Standards Working Group IEEE 802

Re: Amendment of Part 15 of the Commission's Rules for Spread Spectrum
Devices, ET Docket No. 99-231

Proposed reduction in transmit power is not adequate to keep the interference level the same as of current regulation

Interference Potential of Wide-Band Frequency Hopping Systems on Packet Data Systems

Figure 3-3.

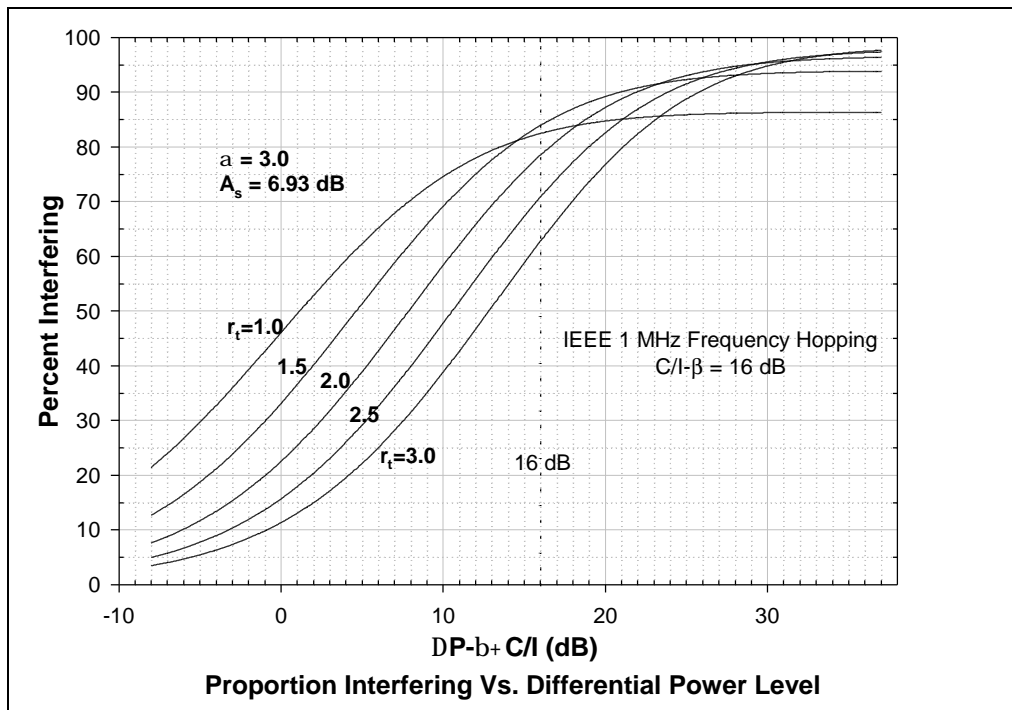
This shows the quantity $(N_a + N_m)/2N_h$ for various ratios of deployment radius to cell radius. Typical values of the parameters α and A_s are used. The vertical dotted line at 16 dB corresponds to the case where an IEEE p802.11 standard frequency hopping wireless LAN victim system has the same power level as the interfering WBFH system.

The curves of figure 3-3 tend to become flat as the C/I requirement of the victim receiver increases. High C/I requirements are characteristic of systems with high modulation efficiency. Thus, the interference effect due to power level difference is relatively insensitive to reducing the interferer power level in high modulation efficiency devices.

Figure 2.0-1 Eb/No vs. BER for FSK and PSK Waveforms

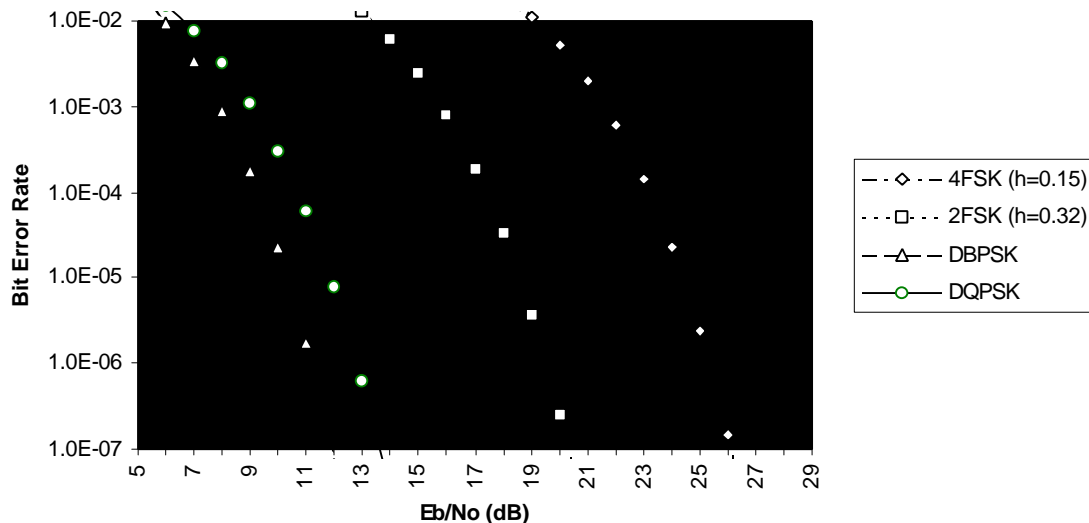
Based on HomeRF’s presentation to the FCC on Feb. 25, 1999 [1] it is clear that the intended modulation scheme is 4FSK. Delivery of 10 Mbit/ data rates using this form of modulation in a 5 MHz wide channel will require a very low index of modulation index (h) of about 0.15. This is an extremely inefficient modulation technique as demonstrated by the Eb/No curves shown in Figure 2.0-1.

In addition, the 4FSK waveform is also highly susceptible to multipath. Due to the inefficiency of the 4 FSK waveform and susceptibility to multipath, WBFH radios will be required to operate at or near the maximum allowable transmit power (+23 dBm). Even at this power level, it is doubtful that a WBFH system as proposed by HomeRF could provide a Quality of Service (QoS) adequate to support the types of multimedia applications described in their letter to the Commission of November 11, 1998.

Figure 3.0-1 Probability of Collision Depends on Hop Rate
(FHSS System @ 128 hops/s)

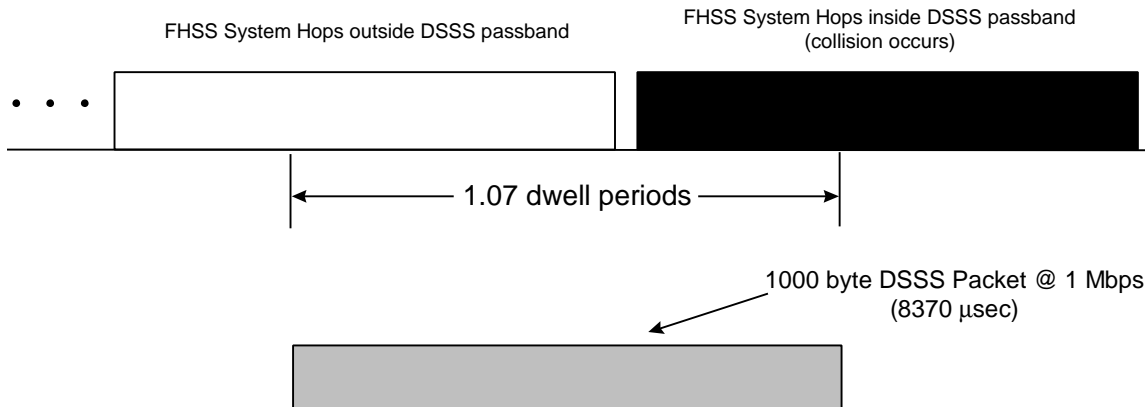
The number of dwell periods overlapped is a function of packet length and the Start-of-Transmission (SOT) time. SOT is a uniform random variable with a range of 0 to t_{dwell} . Based on these considerations and the FHSS system load factor (P_{tx}), the probability of collision for the single DSSS packet under consideration can be computed:

Figure 3.0-2 Increasing Hop Rate Increases Probability of Collision (FHSS System @ 512 hops/s)

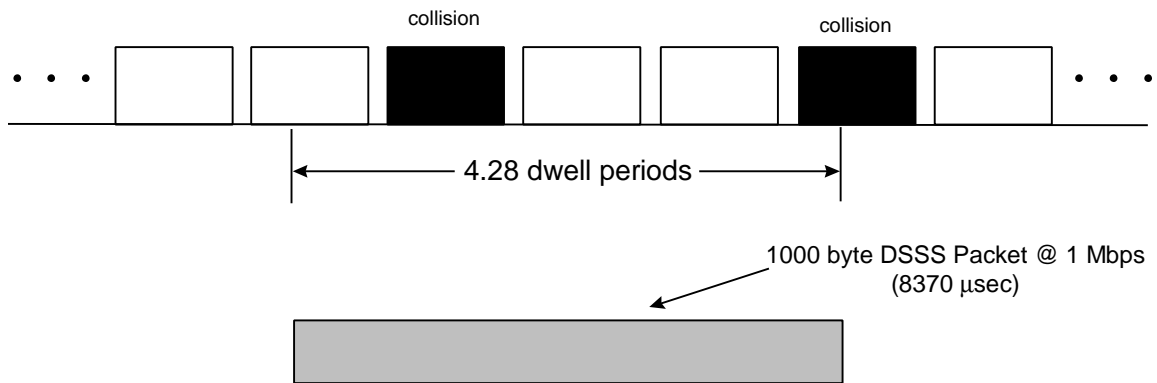
Note that the higher hop rate increases the number of dwell periods overlapped by the DSSS packet. In this situation, the DSSS packet overlaps either five dwell periods or six dwell periods, depending on the start-of-transmission time. The probability of collision for the single DSSS packet under consideration can be computed:

All parameters in Cases 1 and 2 are held constant, except for hop rate. As hop rate is increased, the collision rate increases as well. Therefore, increasing hop rate does not mitigate interference to DSSS users in the 2.45 GHz ISM band. The Probability of Collision is plotted as a function of hop rate for the stated conditions in Figure 3.0-3. Note that as hop rate is increased, the collision rate increases monotonically. There is no point on the curve at which the Probability of Collision *decreases* as hop rate *increases*. This result also holds true when *both* the victim and the jammer are FHSS systems.
